Project Title: Refurbish Elevators and Replace Controls

Solicitation Questions and Answers
for
Refurbish Elevators and Replace Controls
Project: 437-22-101, RFP: 36C26324R0021
12/15/2024

Solicitation Questions and Answers (updated 3-26-2024) for
 Refurbish Elevators and Replace Controls
 Project: 437-22-101, RFP: 36C26324R0021

5 FLOOR PLAN - PATRIOT ELEVATOR 10 - PIT DEMOLITION
1/4" = 1'-0"

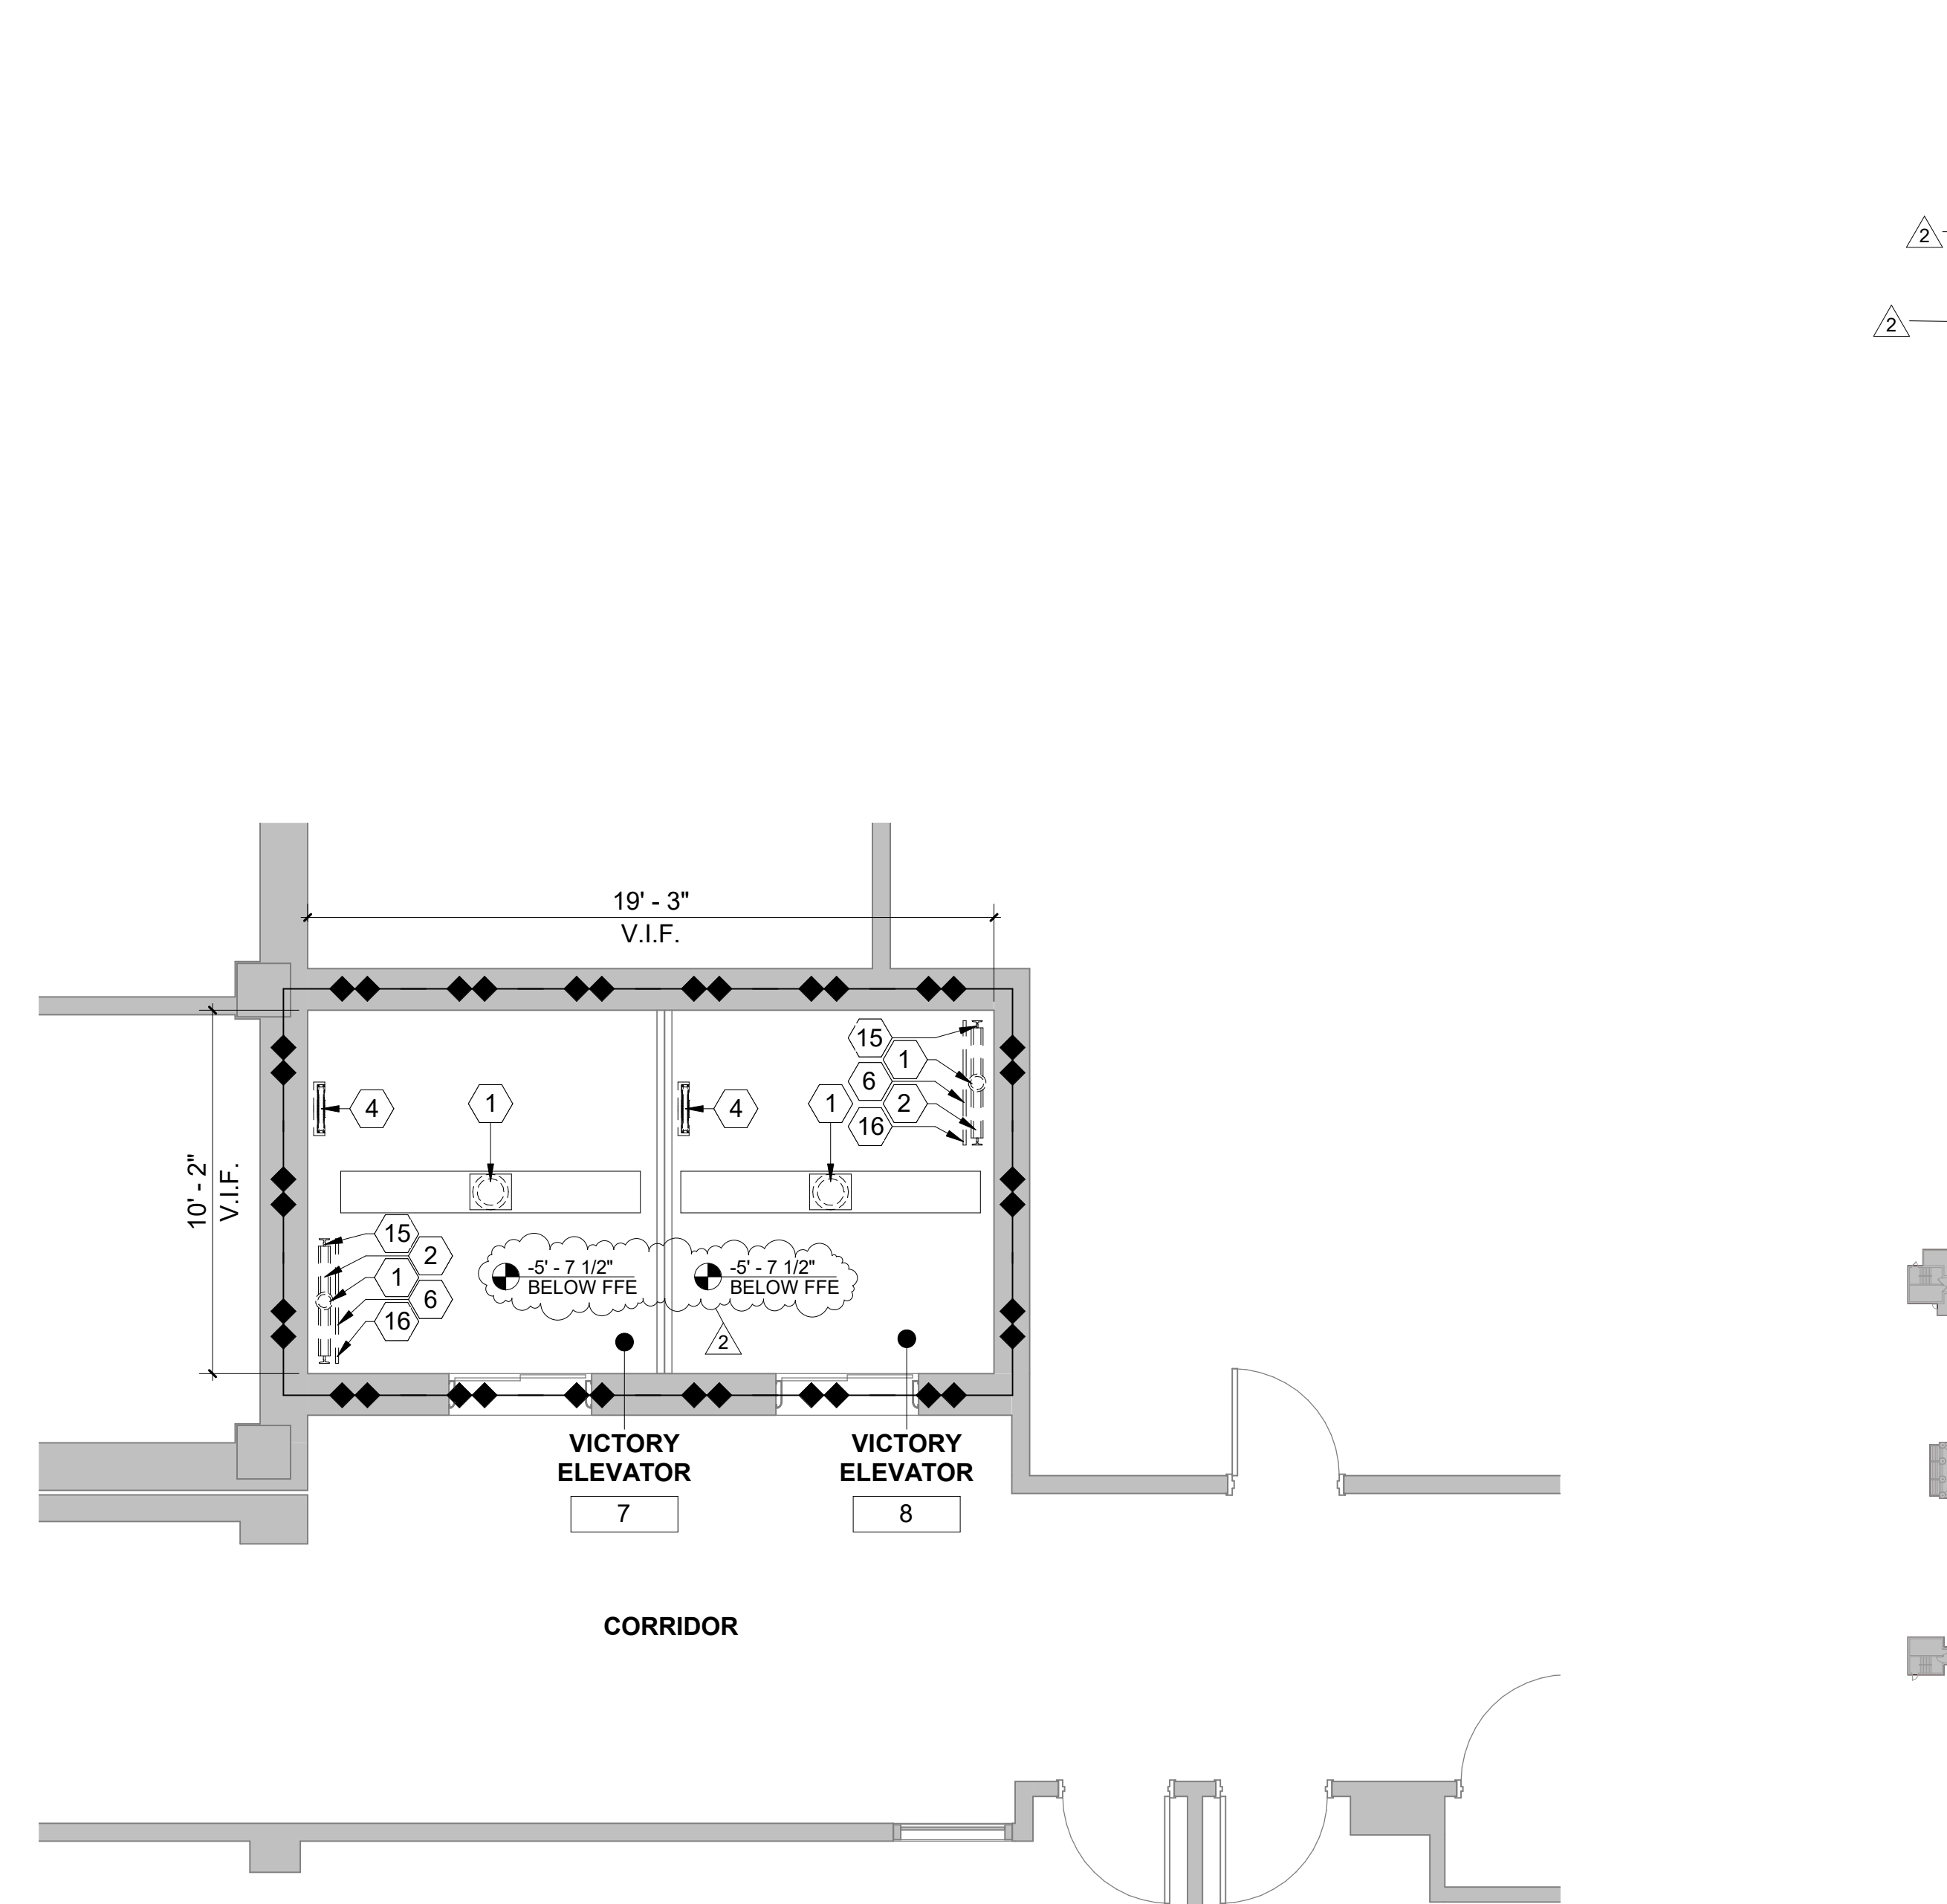
54.	Drawing AD5.20 Key note #12 metal ladders	<p>Per field measurements most ladders in the elevator pit do not meet current code.</p> <p>Are they to remain or be replaced to meet code?</p>	Existing pit ladders to remain. Review on a case-by-case basis will be conducted during construction.

Drawing Sheet AD5.20 ENLARGED PLANS - DEMOLITION – See revised drawing sheet for the adjustment of keynotes # 3, 9, 13 15, 16. Also included is the depth of each elevator pit relative to the floor elevation at the lowest elevator lobby for each hoistway.
